# **Transportation Commission**

## **Bicycle Facility Design Guidelines – Summary of Comments**

# **Exhibit 1: Summary of Comments Received on the Draft Bicycle Facility Design Guidelines**

### Bicycle Facility Design Guidelines – *DRAFT*

**Figure 2. Required clearance from obstructions for Class I path.**

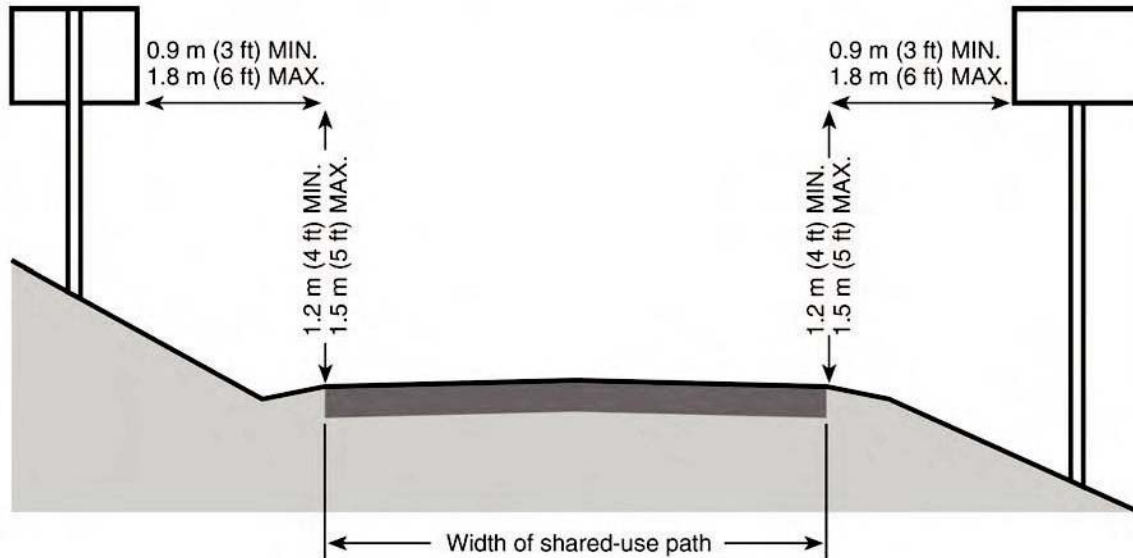
- Bike paths should be ten feet with two feet shoulders not eight feet.
- Bike lane widths should include how the parking lane is defined. The bike lanes are too close to the car doors so she wants to see this revised in the document.

- He seconds what Lucy said.
- On the class I bike paths on page 4 – He would like to see 12 feet as the recommended minimum because these paths become multi-use paths. Twelve feet accommodates multiple conflicts, users, directions and speeds. Twelve feet should be the floor and should be the minimum for each side of the west span of the Bay Bridge. Golden Gate Bridge is ten feet and seems too narrow.
- On Page 34 regarding in-street bike corrals, earlier in the year we had conversations about having them in front of businesses such as Stones Cyclery even on a trial basis.

**Figure 5. Typical design of bike lane where on-street parking is permitted.**

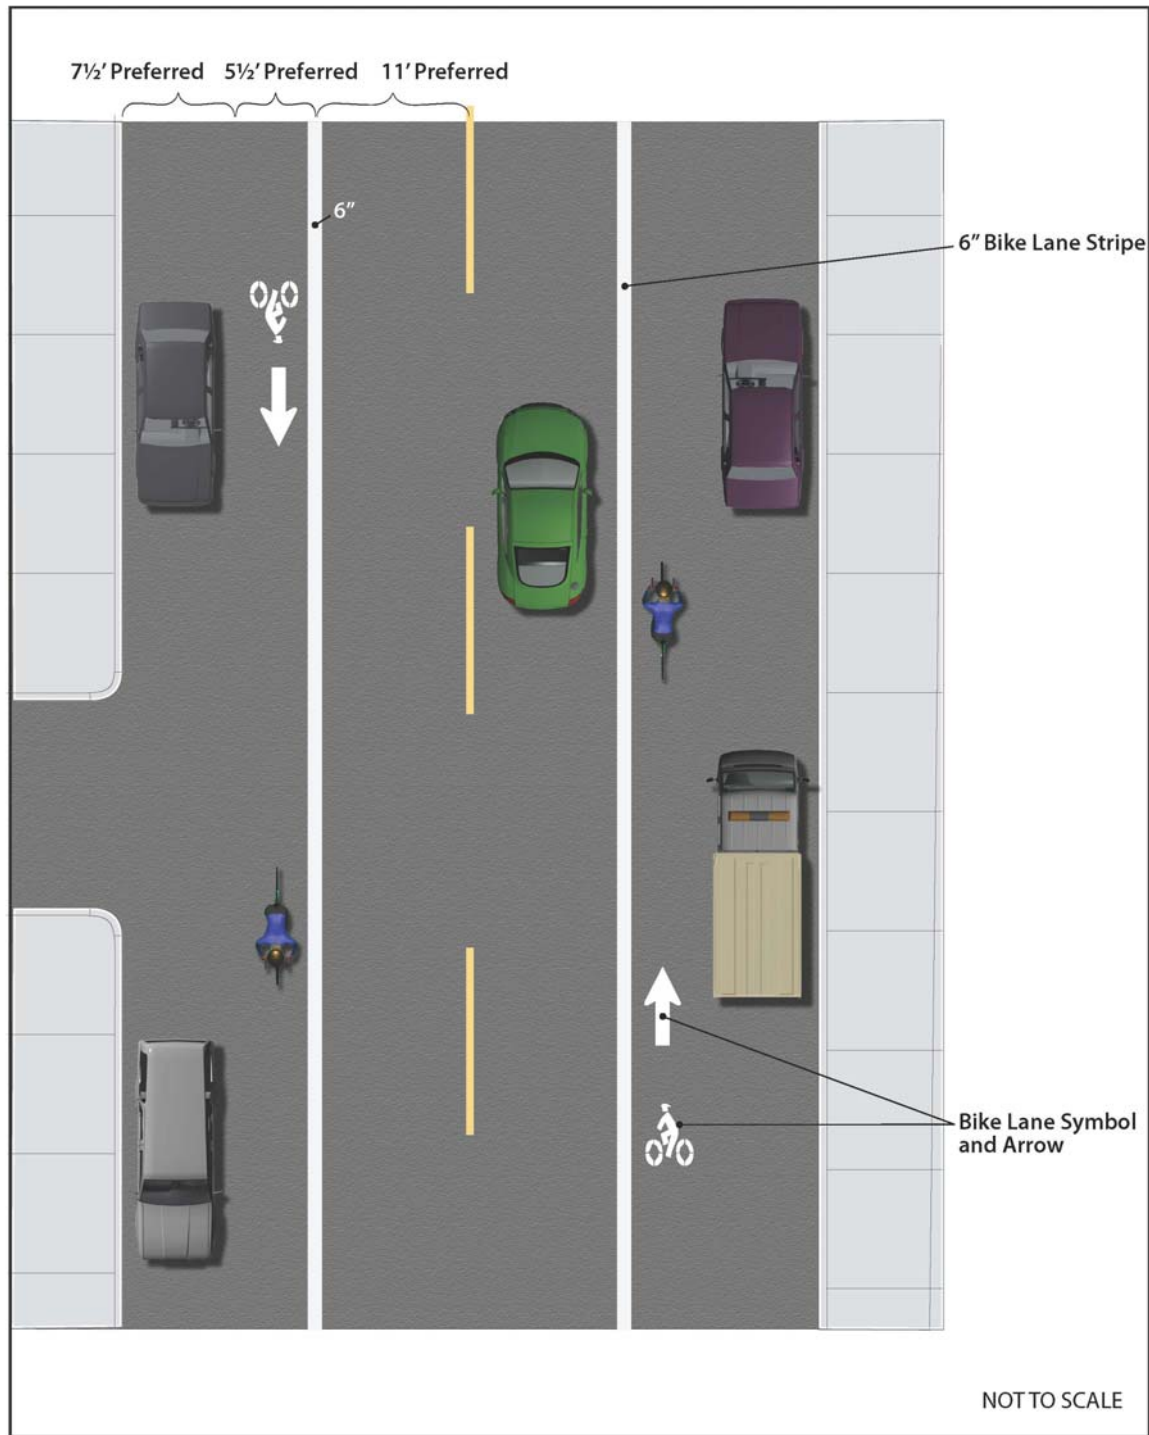
- Page 15 correction? in the picture it lists 7.5 feet preferred parking lane. In the text it says 8 feet.
- Page 40 - bike cage. We recently had an incident where the planning department staff approved a bike cage without bike racks. Please add a comment in this section that says that bicycles are locked to bike racks in a bike cage.

- Class II bike lanes – such as Central Avenue between Willow Street and Oak Street is 5.5 feet – if you recommend an effective door zone of five feet between the bicycle tire and the parked car to allow for sudden doors to be opened, bicyclists on Central Avenue need to ride with their bicycle tires on the bike lane. It says something about the current practice as three feet yet they are talking about changing it nationally because the average door on an SUV is four feet when open. Bicyclists need one foot between the door and the bicycle to ensure that the bicyclist is predictable and safe. He recommends an increase in the width of bike lanes and at least a four-foot door zone.

**Figure 7. Design for buffered bike lane.**

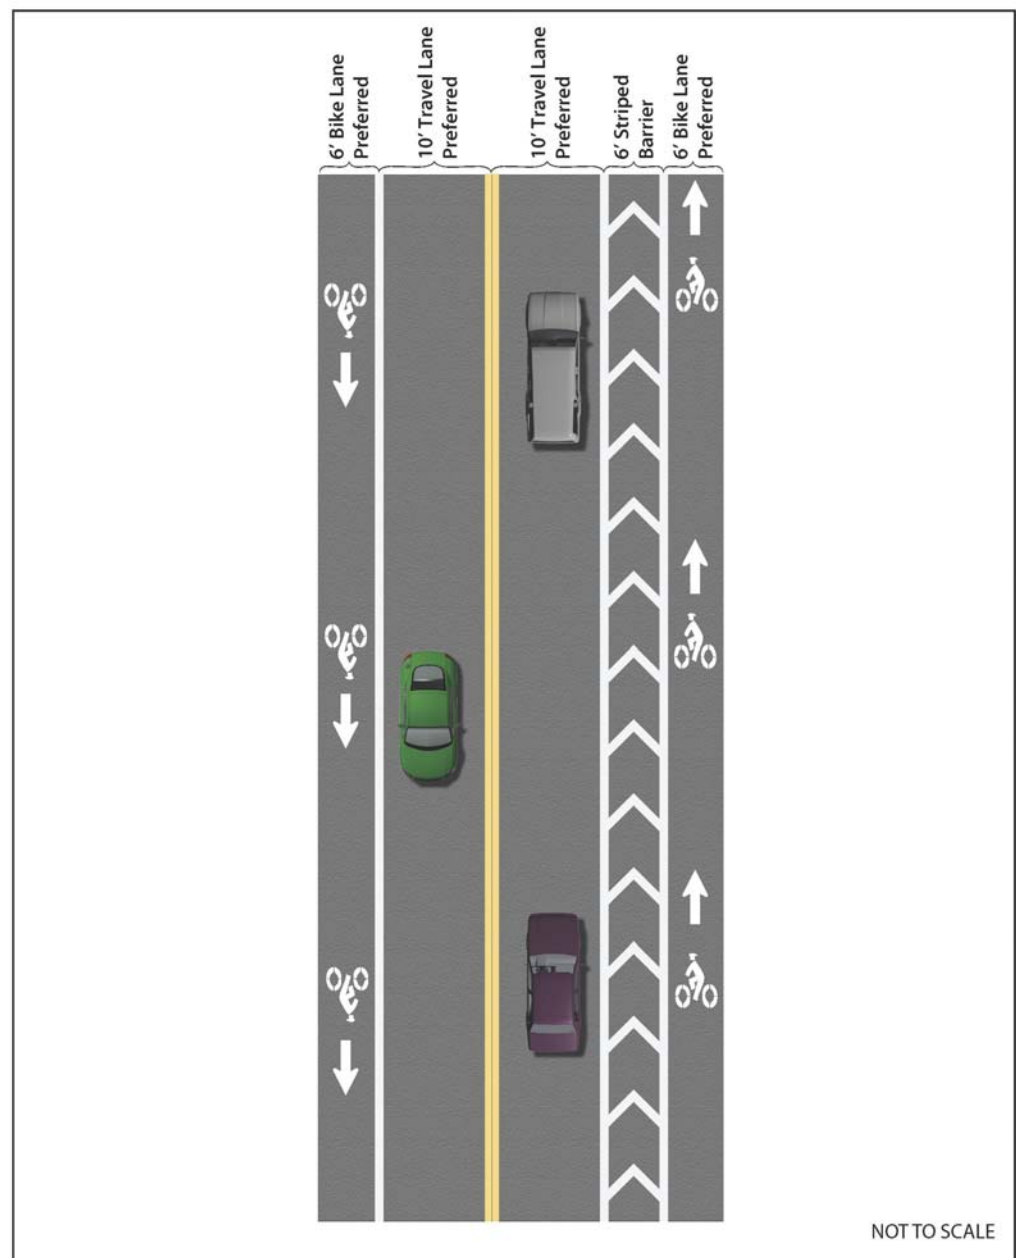
- Page 17 – buffered bike lane correction to the text: A minimum buffer width should be 2 feet. The text says an 8 foot area, which implies a 6 foot bike lane and 2 foot buffer, but the picture shows a 6 foot buffer and 6 foot bike lane.

**Figure 19. Typical dimensions and placement requirements for bicycle racks.**

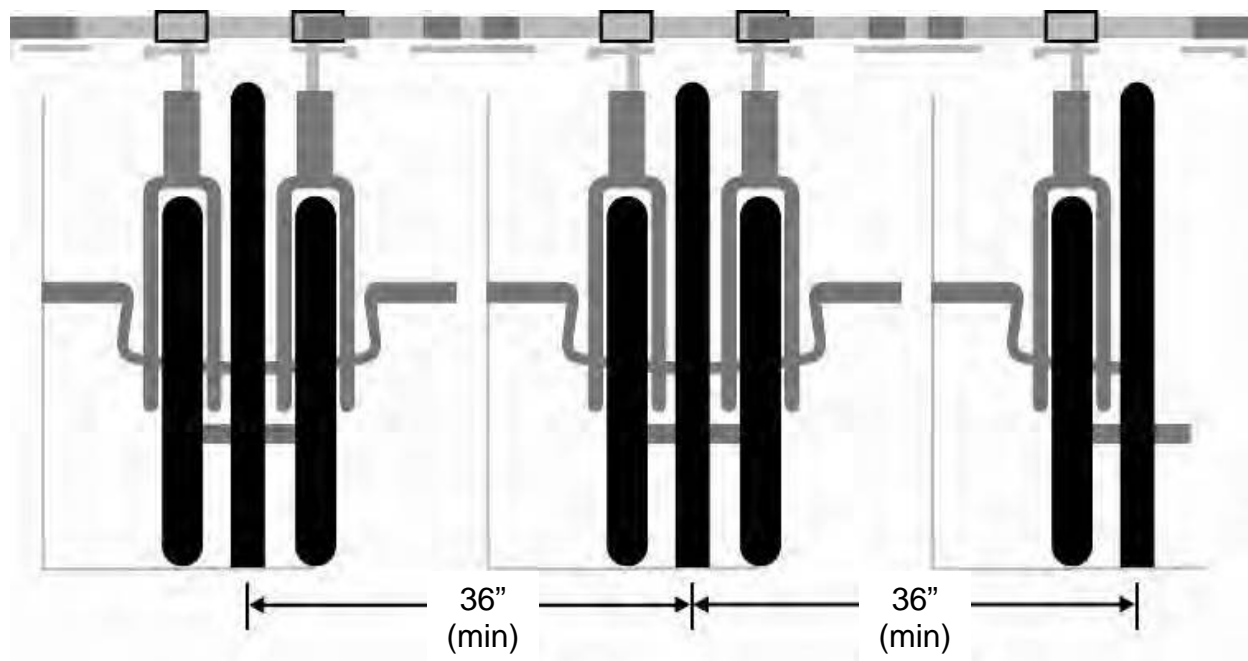
- Can you explain "visibility zone" on page 34? It appears that in the AMC, the zone applies to structures greater than 3 feet which neither a bike nor a rack are.

- Page 34 - Crosswalk spec is 5 feet. Is this the same regulation for auto parking? Is a vehicle allowed to be parking closer than 5 feet to a crosswalk?
